Re: Runway 18/36 Reconstruction and Taxiway Improvements
Mitchell Municipal Airport
Mitchell, South Dakota
AIP #3-46-0037-035-2026
Helms #A-7141

ADDENDUM NUMBER 1

PROJECT: Runway 18/36 Reconstruction and Taxiway Improvements
Mitchell Municipal Airport
Mitchell, South Dakota
DGR Project No. 731501

ADDENDUM NO. 1

**ACCESS ROAD 31 END
CONNECTION (PHASE 3)**
RUNWAY 18/36 RECONSTRUCTION
AND TAXIWAY IMPROVEMENTS
MITCHELL, SOUTH DAKOTA

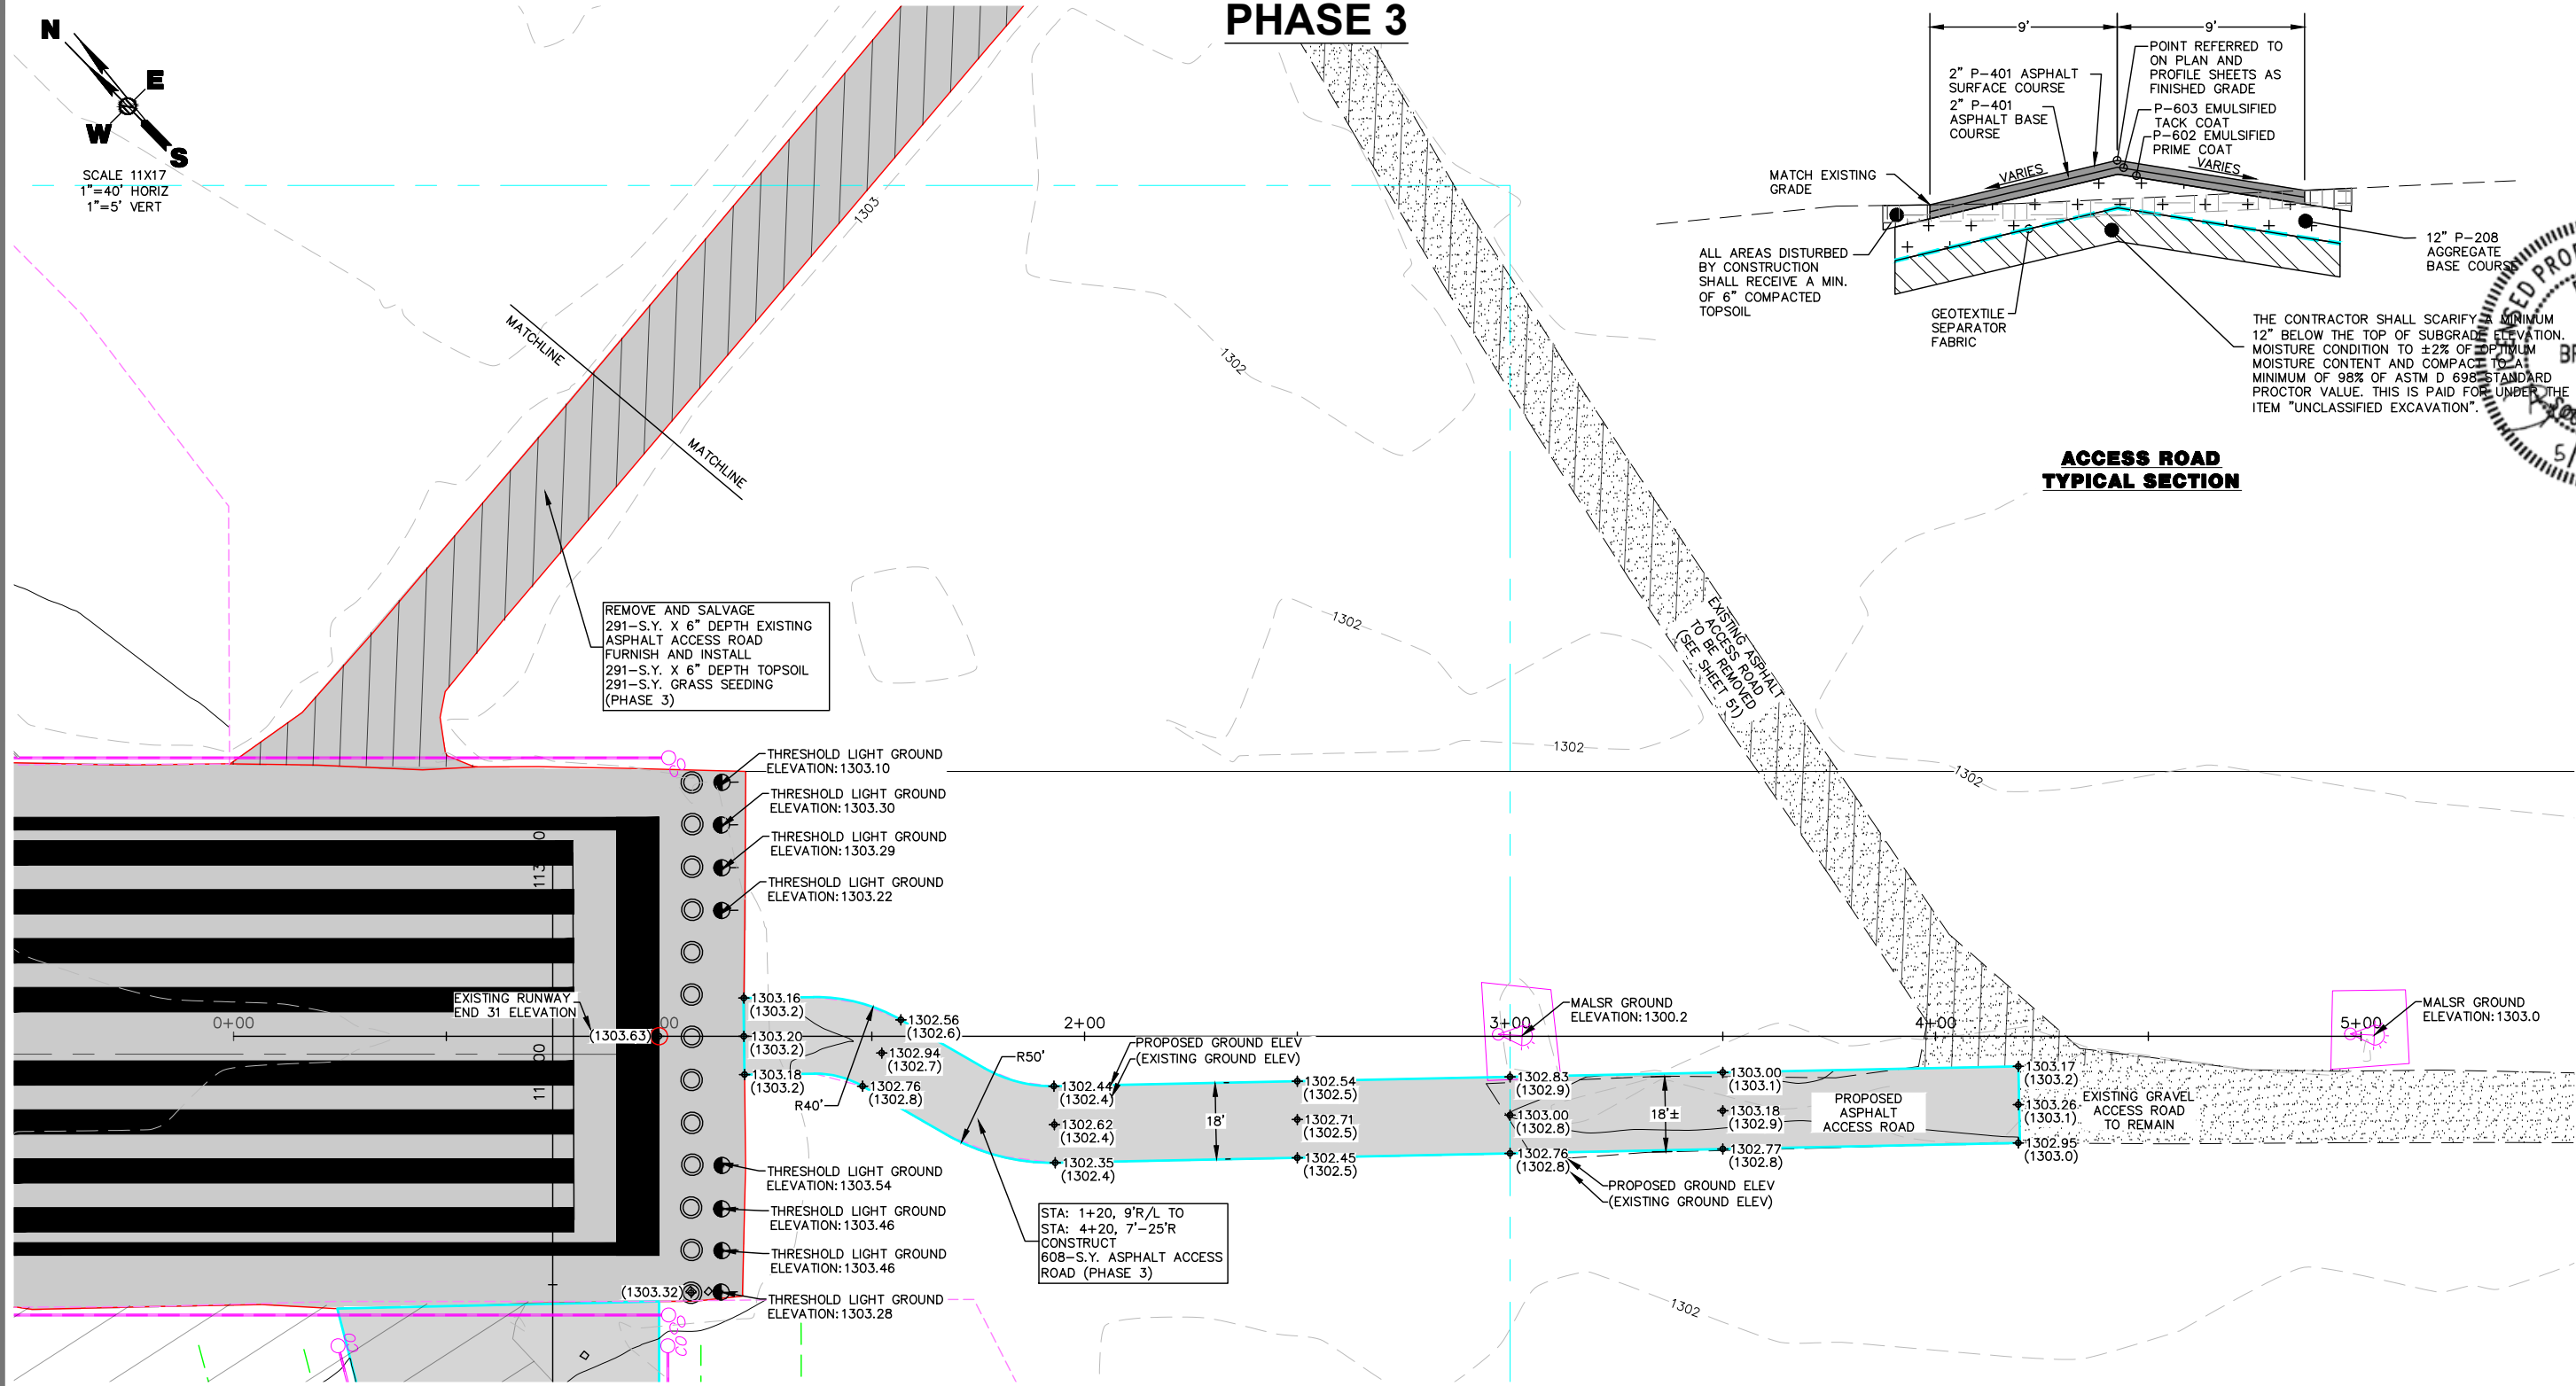
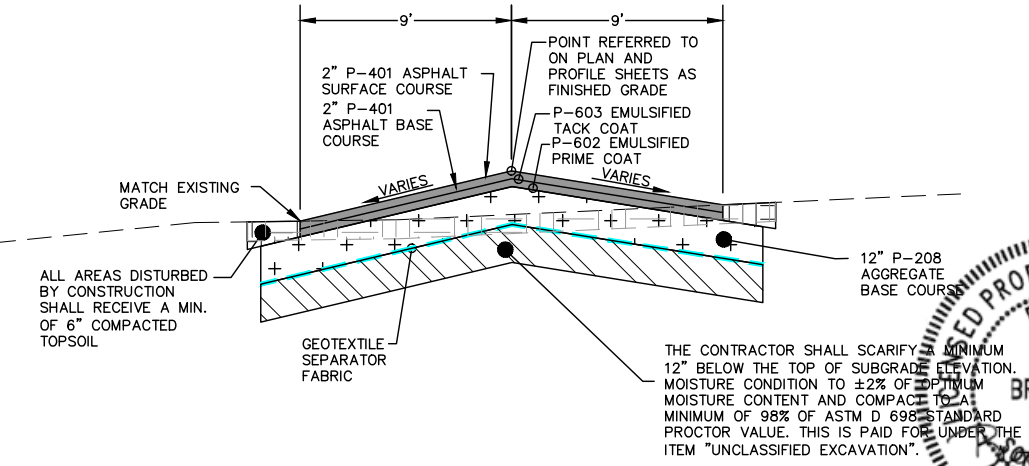
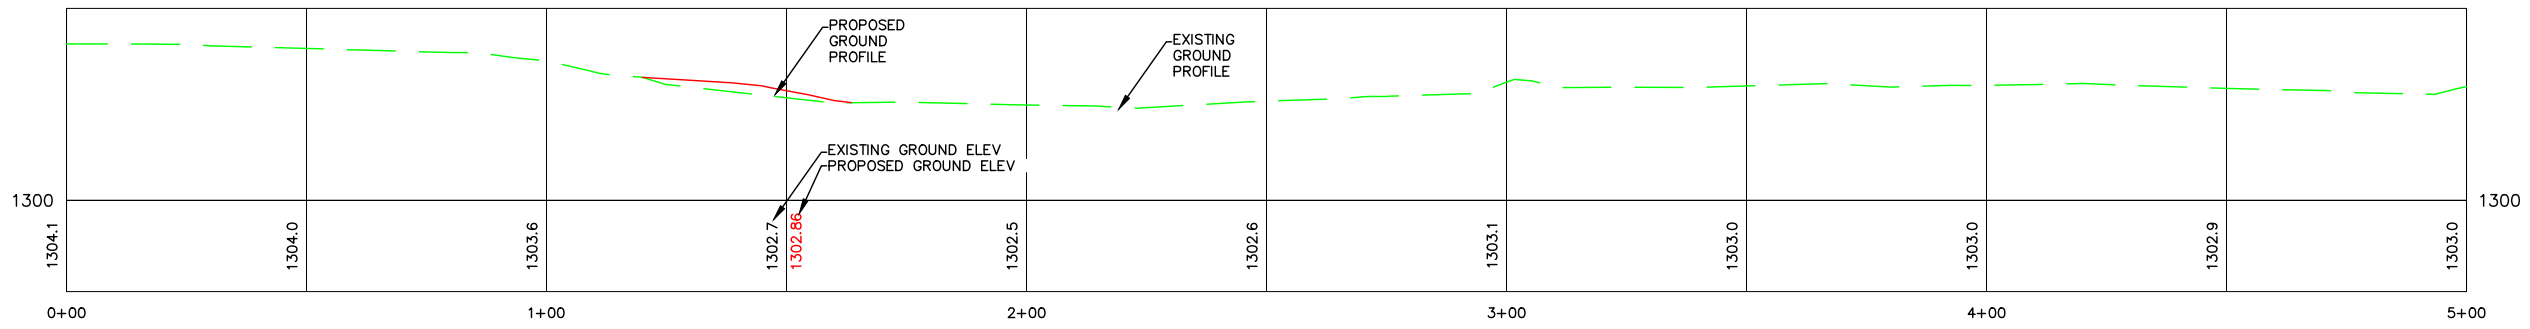
2. Remove sheets 50-51 and replace with the attached pages.

REMOVE AND SALVAGE
291-S.Y. X 6" DEPTH EXISTING
ASPHALT ACCESS ROAD
FURNISH AND INSTALL
291-S.Y. X 6" DEPTH TOPSOIL
291-S.Y. GRASS SEEDING
(PHASE 3)

STA: 1+20, 9'R/L TO
STA: 4+20, 7'-25'R
CONSTRUCT
608-S.Y. ASPHALT ACCESS
ROAD (PHASE 3)

LIGHTING PLAN
BGS | 06-15-2026 | ADDENDUM NO. 1

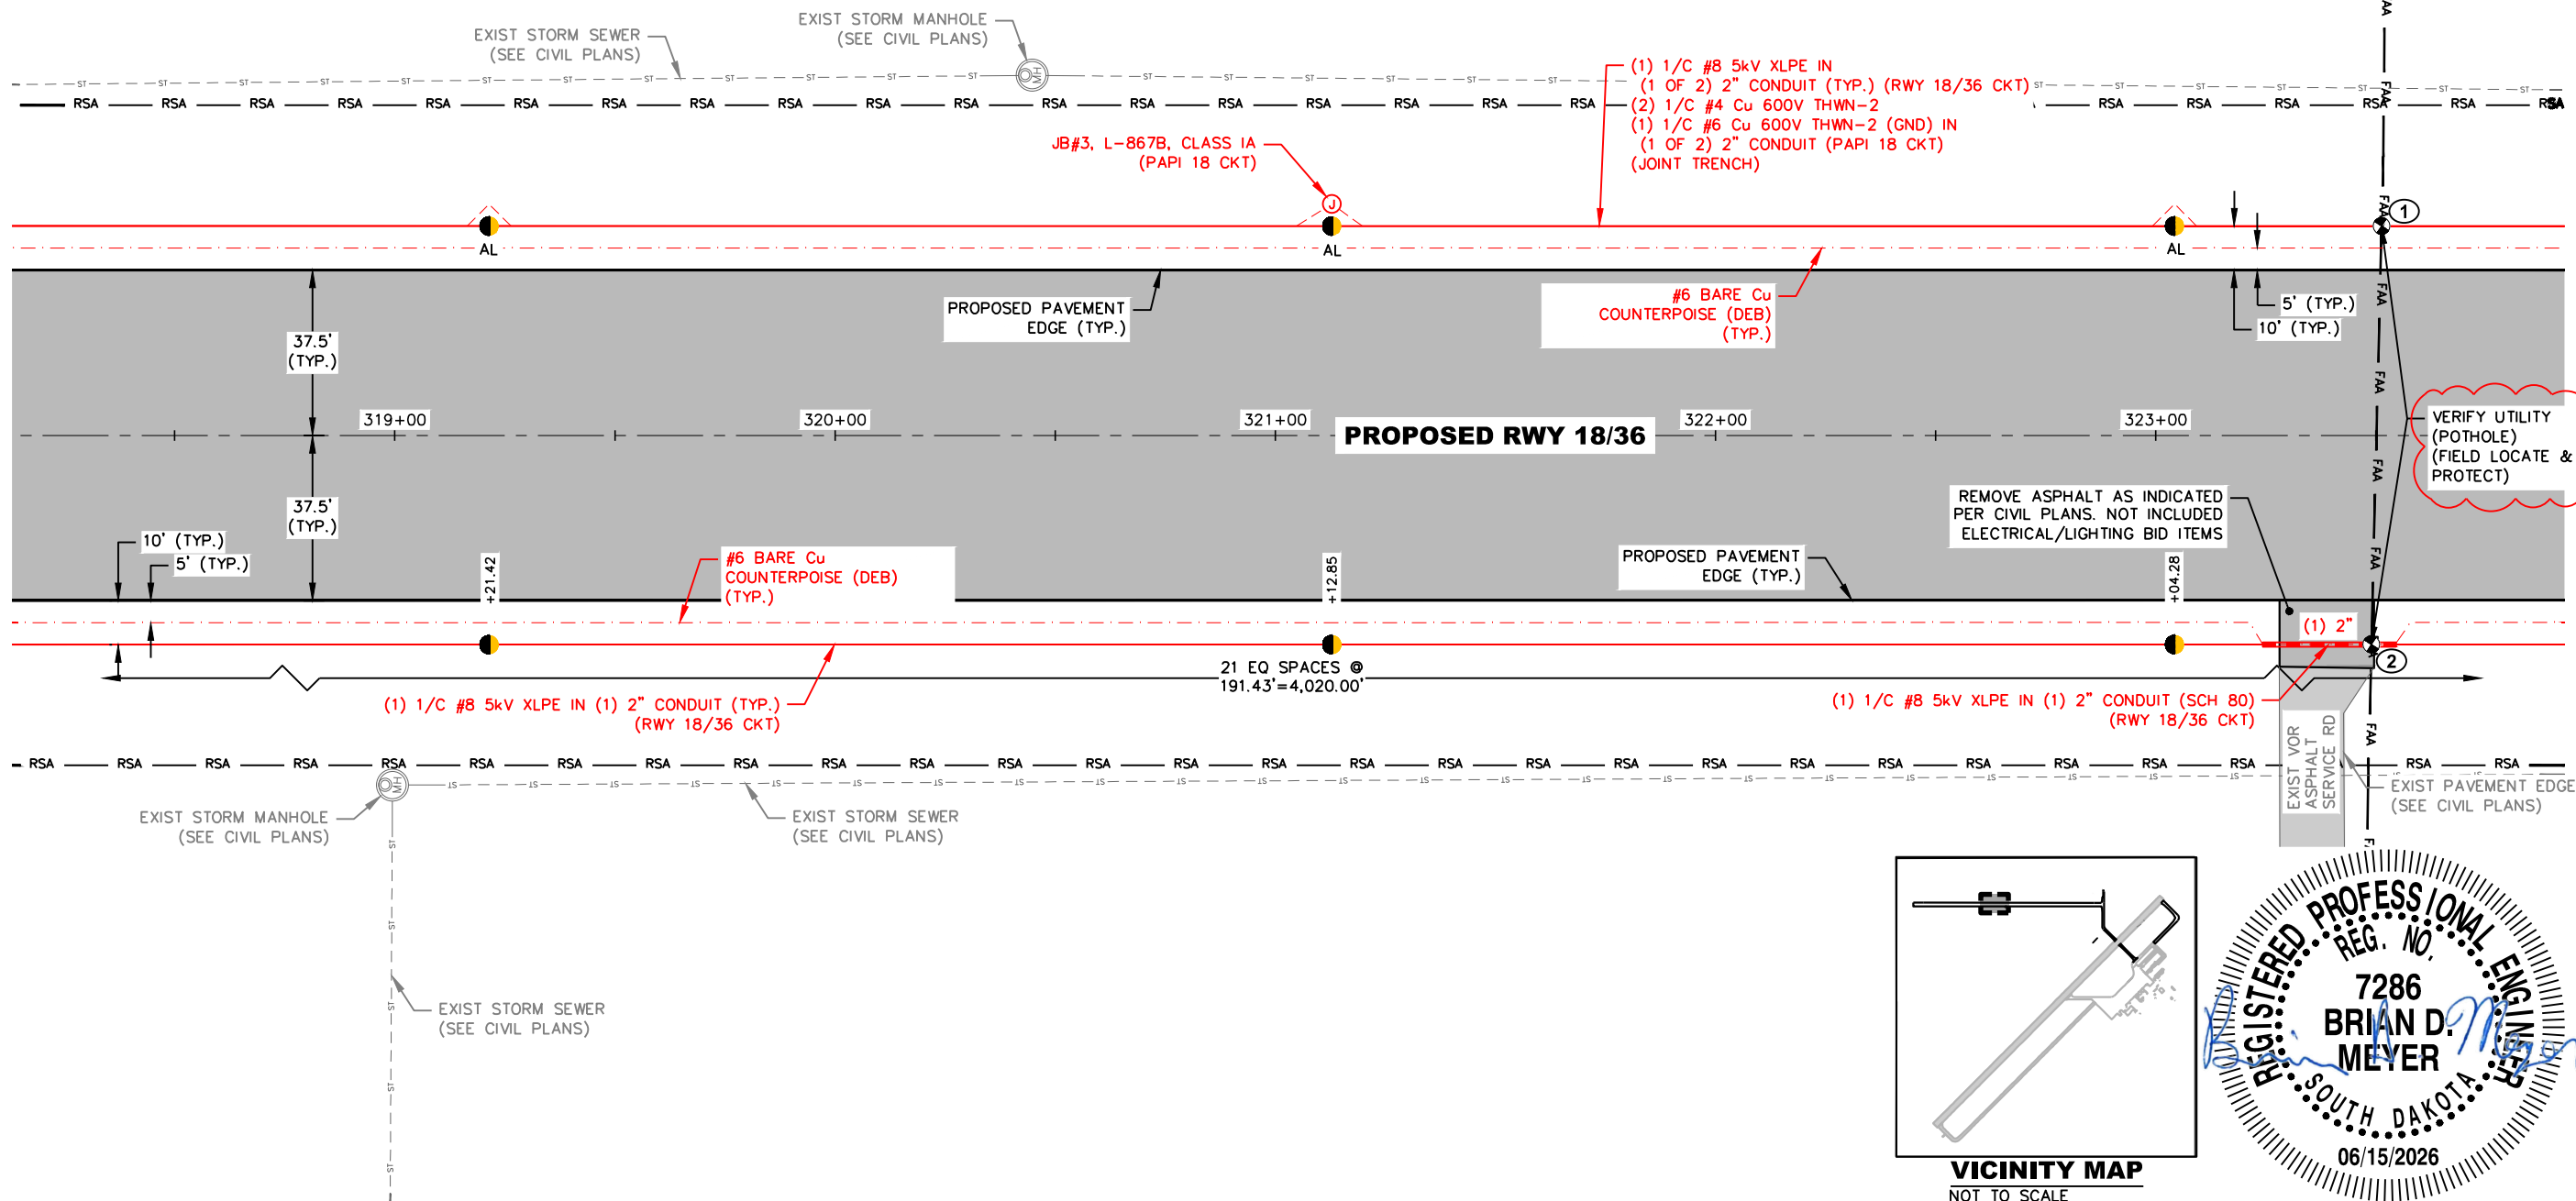
1. REPLACE the following plan sheets with the attached: E2, E30, and E37.

① PRELIMINARY POTHOLING WAS PERFORMED BY THE CITY, WHICH IDENTIFIED THE UTILITY TO BE APPROXIMATELY EIGHT FEET (8') BELOW PRE-CONSTRUCTION GRADE (UAC).

② PRELIMINARY POTHOLING WAS PERFORMED BY THE CITY, WHICH IDENTIFIED THE UTILITY TO BE APPROXIMATELY SIX FEET (6') BELOW PRE-CONSTRUCTION GRADE (UAC).

EXIST FAA OWNED UNDERGROUND GLIDE SLOPE POWER SUPPLY & REMOTE SYSTEM MONITORING (RSM) FIBER OPTIC & COPPER CABLES IN CONDUIT (UAC). ALSO SEE CIVIL PLANS
